PROPOSED CHANGE OF USE - BLDG #5
FOR

LAWRENCE FARMS

1083 RTE 9
T/ WAPPINGER, NY

SITE
PLAN

PARTIAL SITE PLAN
1" = 20'

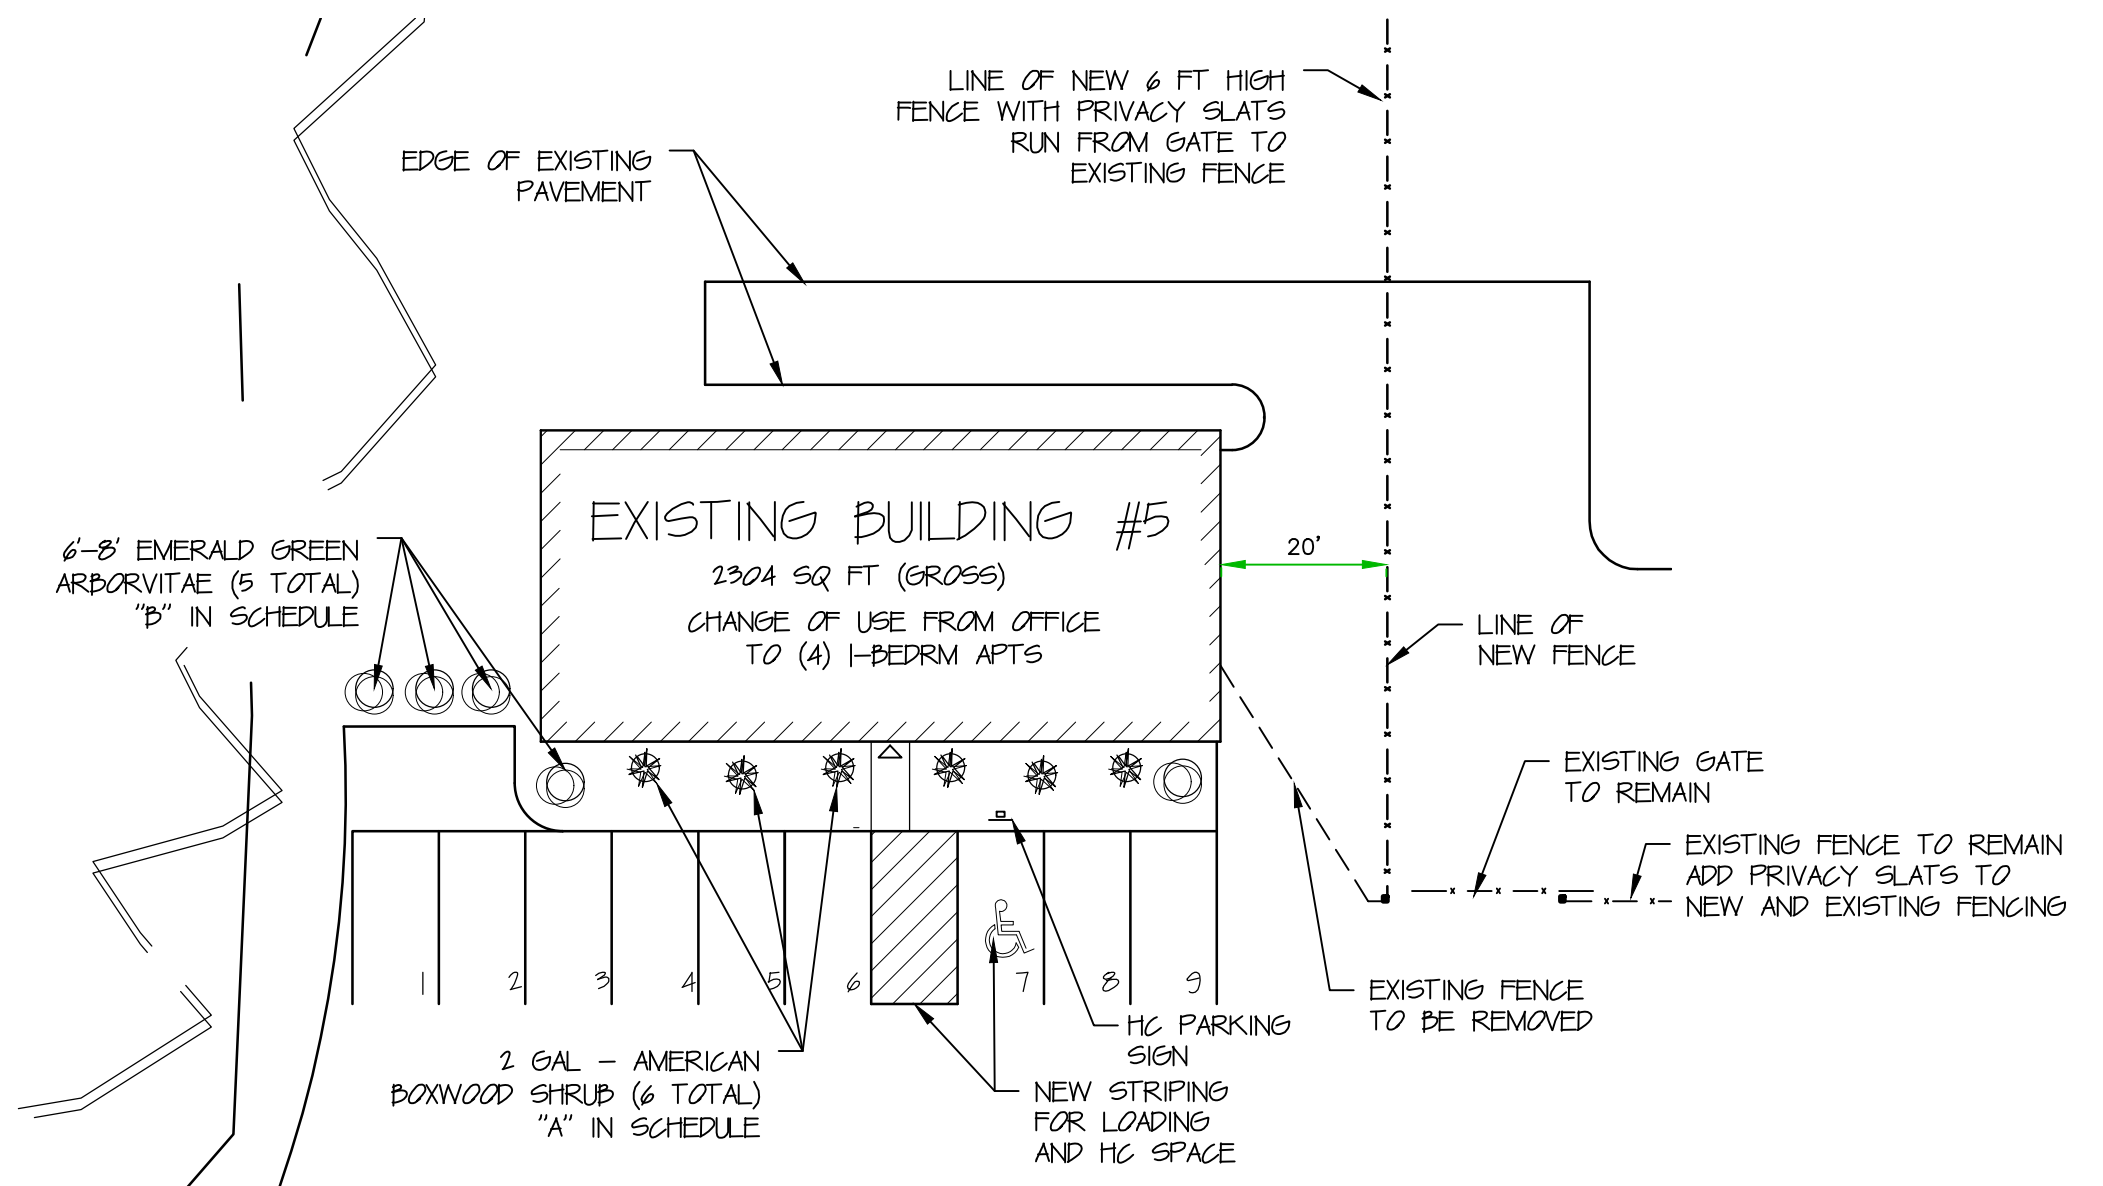
- REVISED ARBORVITAE TO 6-8 FEET TALL.
- ADDED NOTE RE: ZONING ADMINISTRATOR MAY REQUIRE ADDITIONAL PARKING SHOULD EXISTING BE INADEQUATE PER BOARD MTG.
- REVISED CONSTRUCTION FENCE TO SEPARATE BUILDING FROM CONSTRUCTION AREA.
- ZONING ADMINISTRATOR WAIVED BULK TABLE REQUIREMENT AT MTG.

- PARKING LAYOUT UPDATED. PARKING DATA TABLE PROVIDED. REMOVED "COMPACT" PARKING
- NOTED "NO ALTERATION TO EXISTING SITE OR EXTERIOR BUILDING LIGHTING"
- NOTED STORAGE TRAILERS FOR OWNER'S USE. CONSTRUCTION MATERIALS AND EQUIPMENT ONLY. TRAILERS TO BE LOCATED BEHIND PRIVACY FENCE. MINIMUM CLEARANCE TO BUILDING NOTED.
- LANDSCAPING SCHEDULE WITH SCIENTIFIC NAMES ADDED.
- ADD PRIVACY SLATS TO EXISTING AND NEW FENCING

- REVISED PARKING TABLE TO SHOW EXISTING AND PROPOSED PARKING COUNT
